Introduction

I found these books to be very helpful for specific problems and troubles as found and documented by the TV manufacturers themselves during the 50's. I decided they would be helpful to others in the hobby of fixing up and obsessing over old TV's like myself. Please let me know if you see any issues with the scans or need clarification on something that is not clear/visible in a scan.

VOLUME 4

Fig. 34 — Sears Roebuck

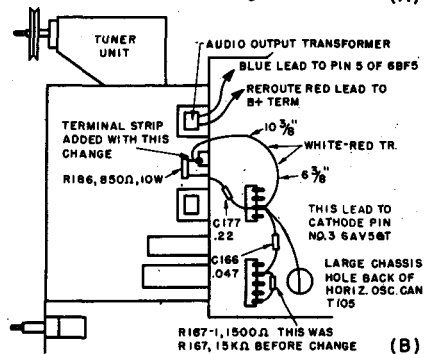
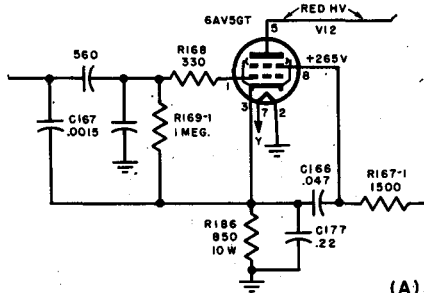
Later production of the above chassis incorporate the accompanying circuit change to decrease the dissipation in the 6AV5GT horizontal-output tube and increase the life of this tube. In every case where a model 106 or 107 with the above chassis is returned for service, this change should be made. The following parts, available as a kit (part

Fig. 35 — Sears Roebuck

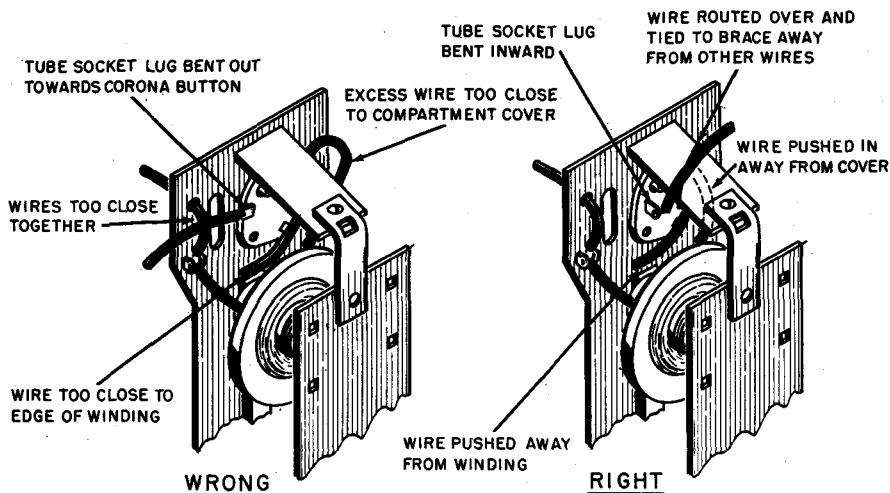
In the future the leads in the compartments will be kept as short as possible with any excess pulled through to the back side of the bakelite mounting base and then routed through an additional polyethylene sleeving.

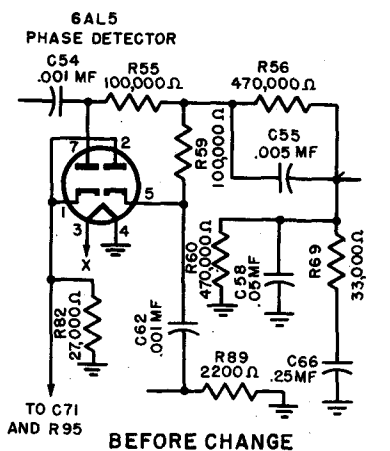
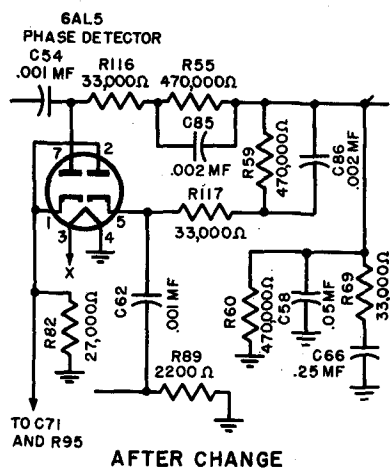
tendency for the above models to require a different setting of the horizontal-hold control when the set was first turned on (cold) and after it was warmed up (hot). To correct this, the following changes have been incorporated in chassis having Series YG ink-stamped on the back of the chassis. They are not included in chassis stamped Series YA, YB, YC, YD, YE and YF.

1. The .005- μ f capacitor *C55* and the 470,000-ohm resistor *R56*, parallel filter in the output circuit of the 6AL5 phase detector, are removed from the circuit.

Fig. 45 — Sentinel

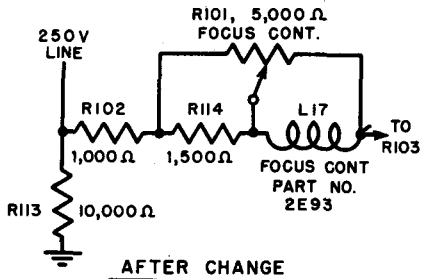
3. The B+ take-off point for the audio section is moved to the variable tap on the horizontal-centering control.

Fig. 48 — Sentinel

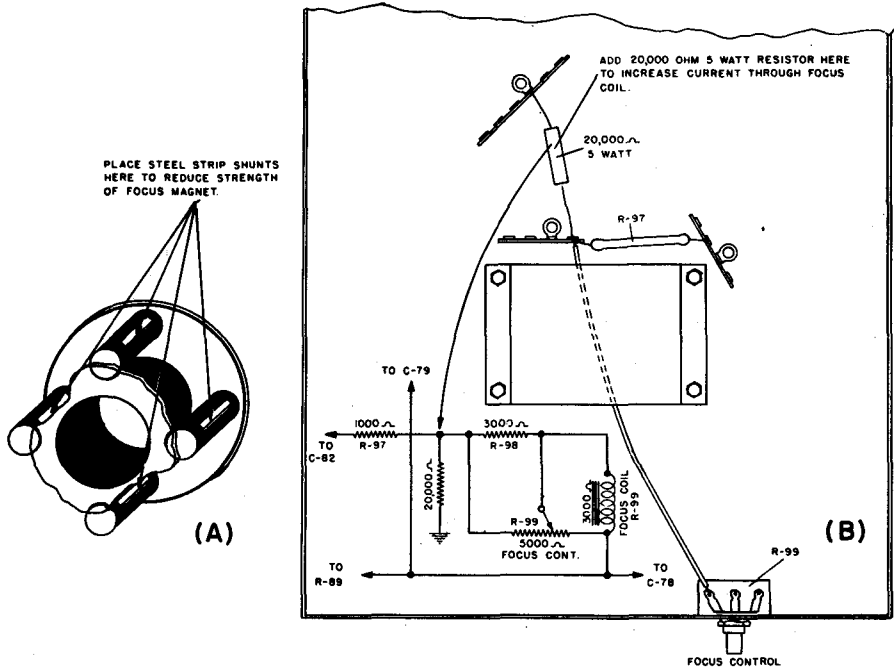
Place four steel strip shunts, approximately $\frac{3}{4}$ " \times $\frac{1}{8}$ " \times $\frac{1}{16}$ " around focus magnet as shown in part (A) of the figure. If this brings position of proper focusing within range of the focus control, no other changes are necessary. Should the addition of the four steel strip shunts improve focusing but still not bring correct focusing within the range of

Fig. 57 — Shaw TV

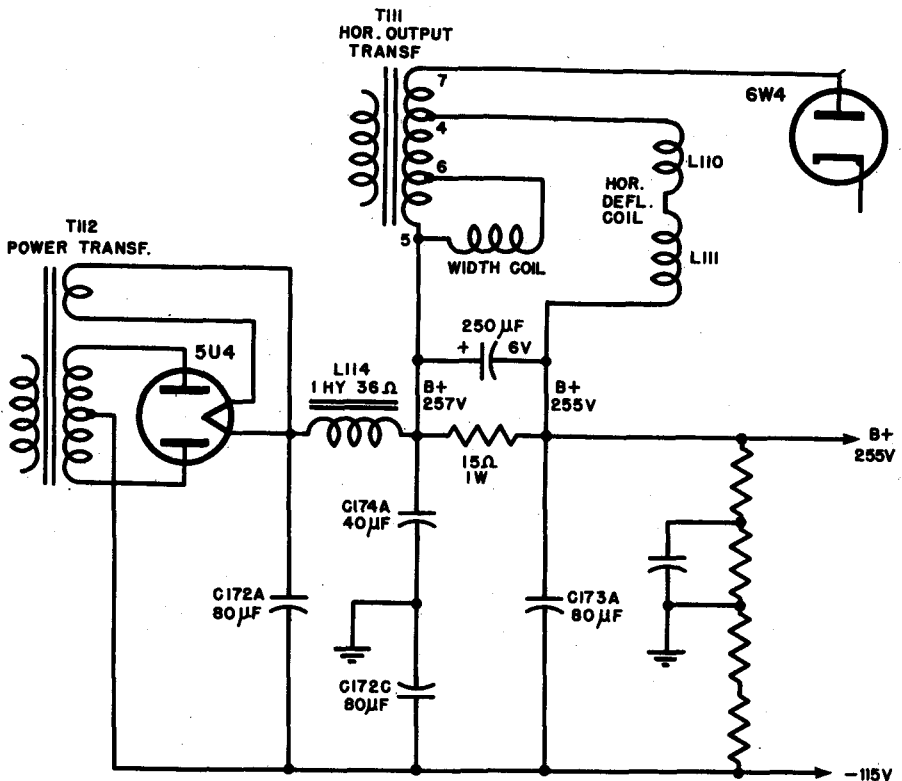
SHAW TV Chassis 224
Improved horizontal centering
 (see Fig. 57).

Fig. 58 — Shaw TV

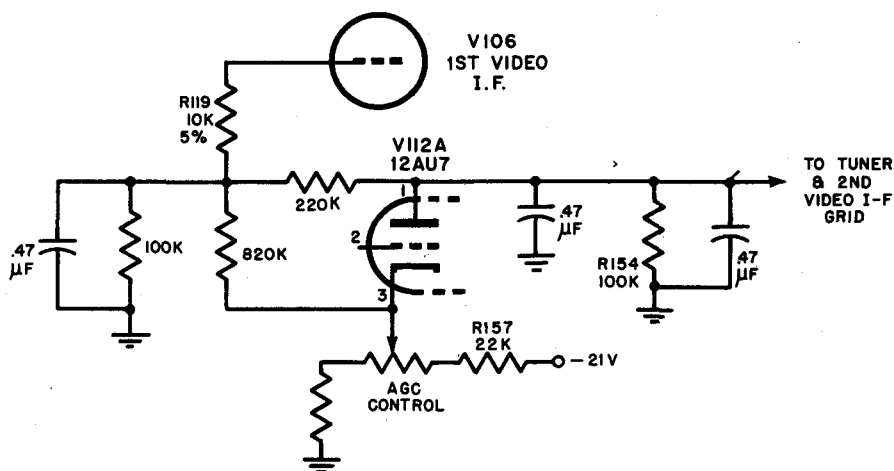
Buzz on either side of correct tuning position (see Fig. 58).

1. Mount a single-lug terminal strip under the nut of the discriminator can (closest end to *V112* age tube).
